August 29, 2022
File: 213403364

Reference: Response to Public Comments
Sitewide Fate and Transport Remedial Investigation Report
Sitewide PADEP Facility ID No. 780190
Former Philadelphia Refinery
3144 Passyunk Avenue
City of Philadelphia
Philadelphia County

RESPONSES TO CAC COMMENTS

See Fate and Transport report, [Part 1](#), page 3.26 (emphasis added).

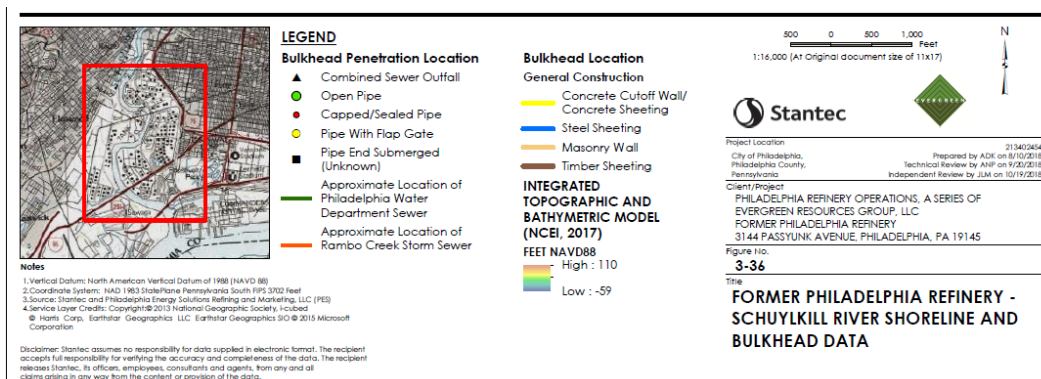
Now, Evergreen has offered a modeling analysis that does not provide specifications relating to hydraulic “conductance” (which is assumed to be the hydraulic conductivity of the barrier divided by the thickness (*see* USGS, Online Guide to MODFLOW-2005, [HFB6 - Horizontal Flow Barrier Package \(usgs.gov\)](#)) or depth of the Horizontal Flow Barrier (HFB) package. Instead, Evergreen offers a brief and somewhat vague description of the efforts to parameterize this important model feature:

Along the facility, much of the Schuylkill River shoreline has been hardened with sheet pilings and bulkheads to stabilize the channel, provide shipping access, and mitigate the potential for erosion and flooding. As discussed in **Section 3.1.1** and **Section 3.1.2**, shoreline hardening had already commenced by the turn of the 20th Century near the facility. Where **present and not deteriorated**, sheet pilings act as hydraulic barriers that limit the horizontal exchange of groundwater with surface water and vice-versa, depending on the depth to which the pilings are anchored. Stantec and Evergreen met with PESRM engineers during January 2018 with the goal of obtaining any available as-built information related to bulkheads and other shoreline structures (**Appendix C**). A site walk was also performed to visually review the structures. Based on the information received from PESRM, Stantec compiled and digitized the locations of bulkheads, bulkhead types, and walls along the Schuylkill River, also noting where the shoreline appears to be open (**Figure 3-36**). Most drawings reviewed did not indicate the installation depth for sheet pilings, only noting that the sheeting is generally driven to refusal based on geotechnical standards. As such, **the vertical extent of hydraulic flow barriers in the GWF model was estimated during model calibration to observed hydraulic heads (Section 6).**

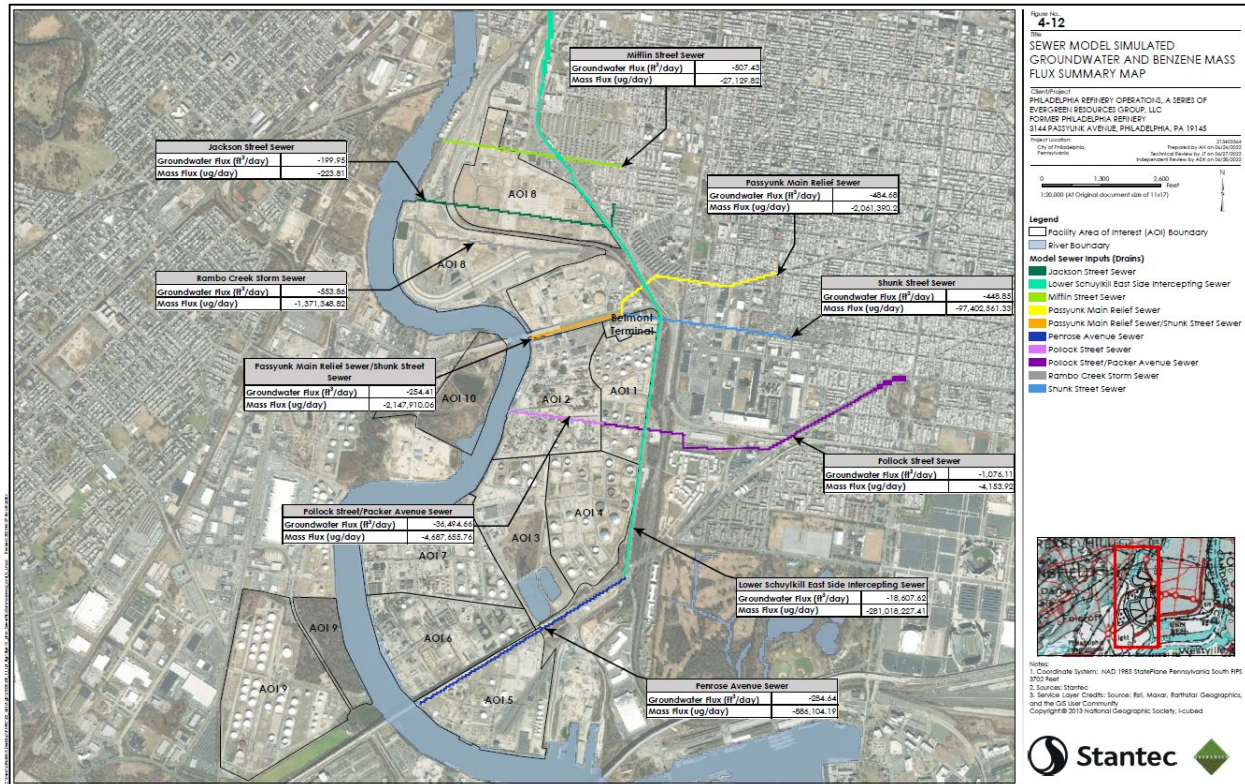
There is no discussion of how the material or expected age of the sheet pile walls affects initial estimates of the conductivity or thickness of the HFB cells. For example, large sections of AOI-8 and AOI-9 are identified as having timber sheeting, which appears to be given the same initial parameters as steel sheeting. *See id.*, Part 1, Figure 3-36.

In Figure 5-4 (PDF page 114 of 1431) Evergreen shows the extent of the HFB. Areas where the bulkhead material transitions from one type to another appear to be modeled as a continuous horizontal barrier. But it seems unlikely that bulkhead sections made of different material and installed at different times would be tied together well enough to prevent groundwater flow to the river. There are inconsistencies between the mapped bulkheads and the HFB that are not explained. For example, sheet pile walls are mapped in AOI-8 and AOI-2 on Figure 3-36, but it is not modeled according to Figure 5-4.

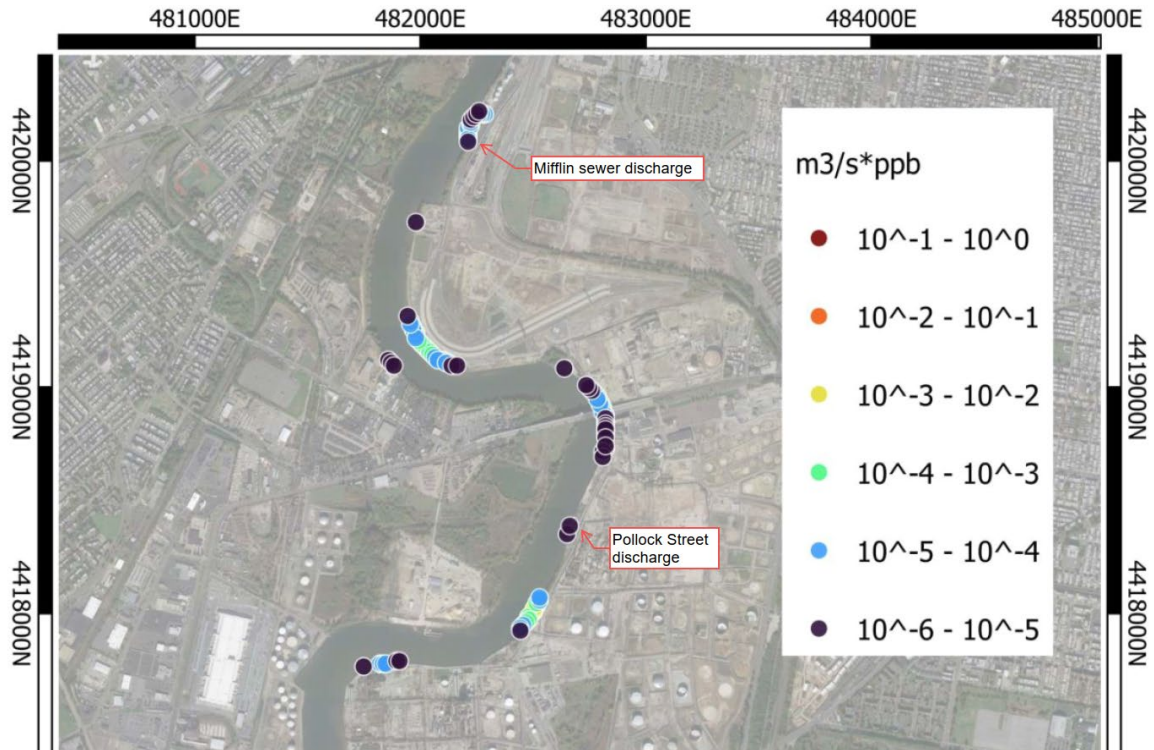
Evergreen presents Benzene mass flux from sewer systems on Figure 4-12:

However, in the report describing the river modeling, a contradictory Figure is presented showing Benzene flux into the river:

This comment references two different sets of groundwater contaminant mass flux estimates for benzene. F&T RIR Part 2 Figure 4-12 was developed to show the estimated total flux of dissolved benzene into the City of Philadelphia (City) combined sewer system and represented by the Drain (DRN) package in MODFLOW. Under typical operating conditions represented by Evergreen's models, the City's sewers are designed to route flow to the Lower Schuylkill River East Side Intercepting Sewer where it is transported to a regional wastewater plant. As such, this pathway of contaminant transport is not interpreted to represent a steady-state flux to the Schuylkill River but was provided to inform the contaminant transport pathway to the City sewer system.

Figure 5. Thickness of the upper clay unit (model layer 2) of the Potomac-Raritan-Magothy aquifer system in the south Philadelphia area.

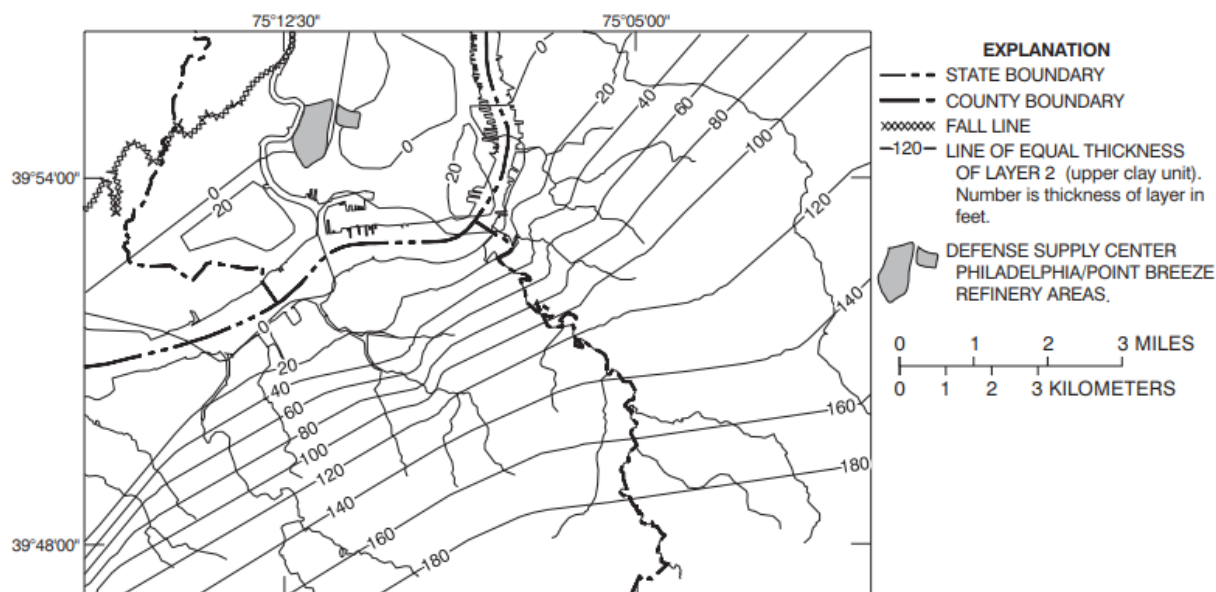
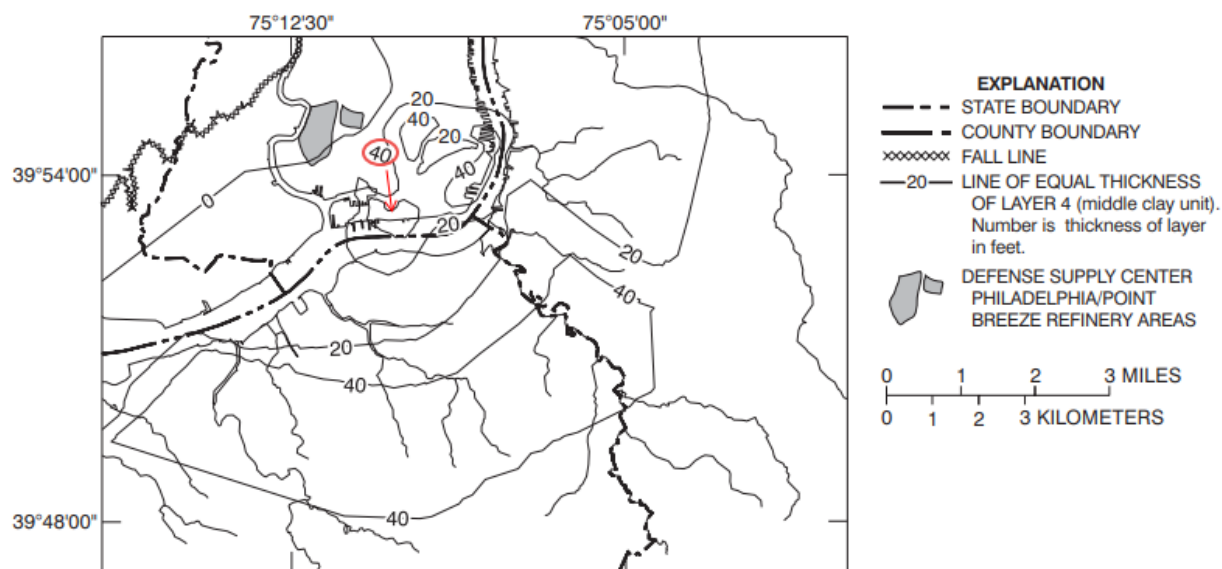
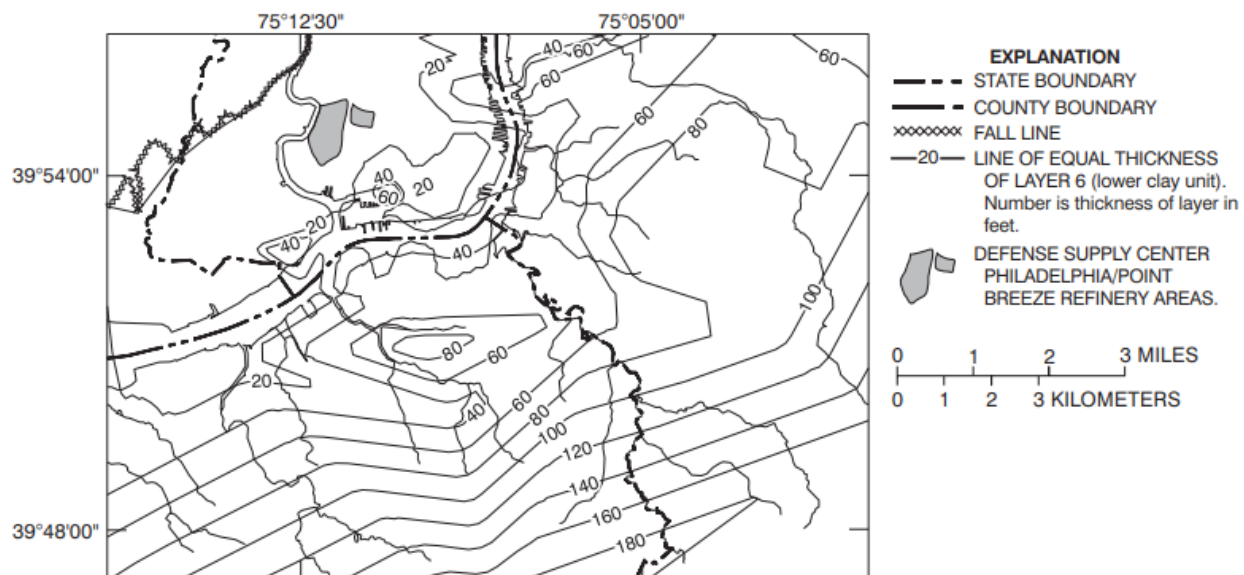
From these data, the USGS has developed isopach thicknesses for the deeper clay units. Its isopach maps are an essential element of its conceptual model. The USGS sets them forth in the following three Figures:

[2017 Report](#) (AOI-5), Figure 4 (Geologic Cross Section Location Plan).

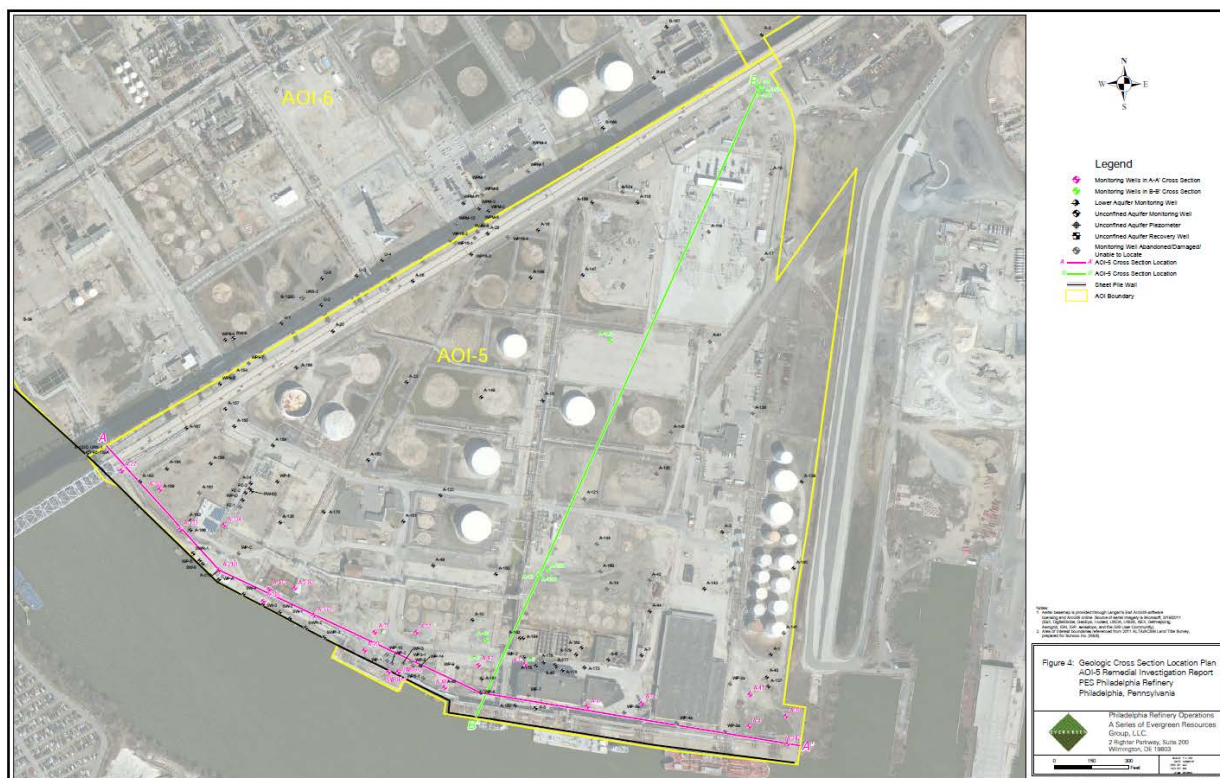
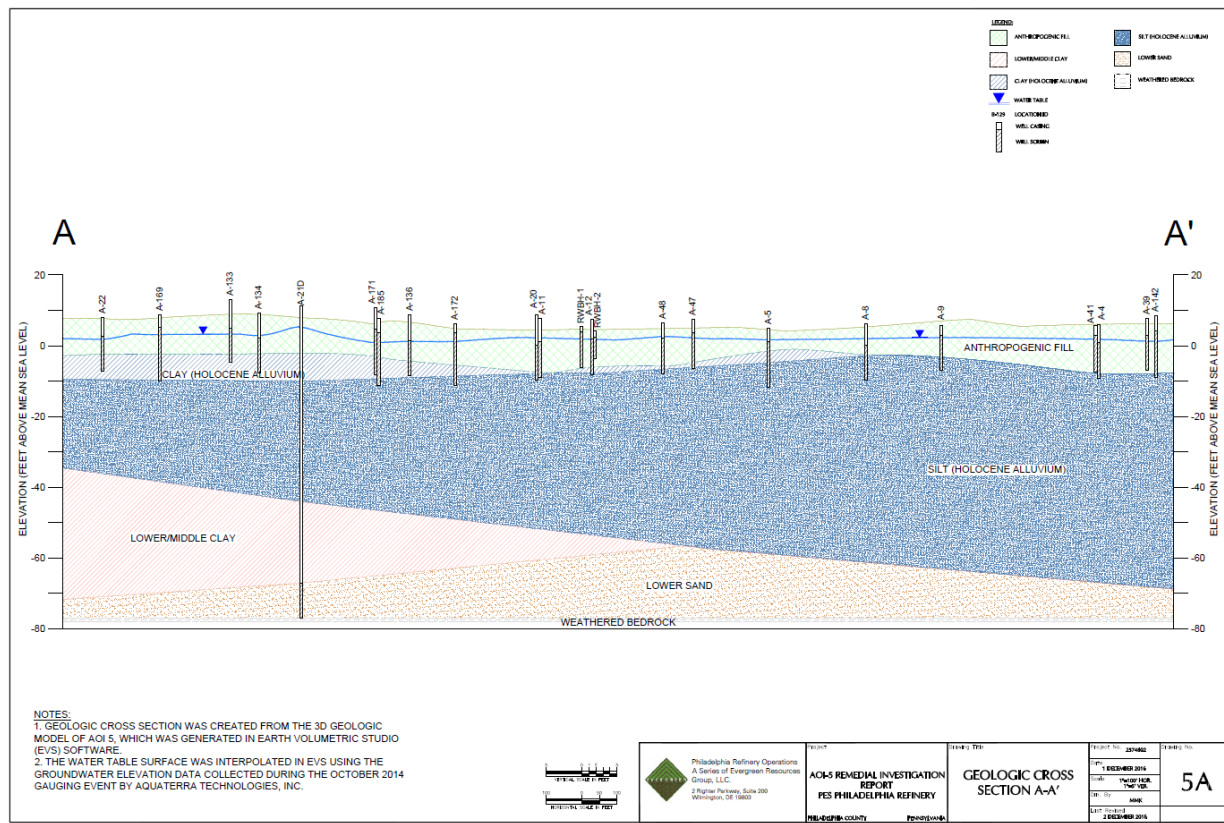
Instead, one must look to other evidence to ascertain the depth to the water table from the surface. Evergreen has provided geologic cross sections for all Areas of Interest. To illustrate with respect to AOI-5, the following Figure from the 2017 report identifies two cross sections -- an A-A' cross section generally running from west to east (in pink), and a B-B' cross section generally running from north to south (in green):

The following Figure displays a side view of cross section A-A', looking from the south toward the north. Throughout all of this cross section, the distance between the yellow line at the top (the surface) and the blue line below (the water table) is less than ten feet:
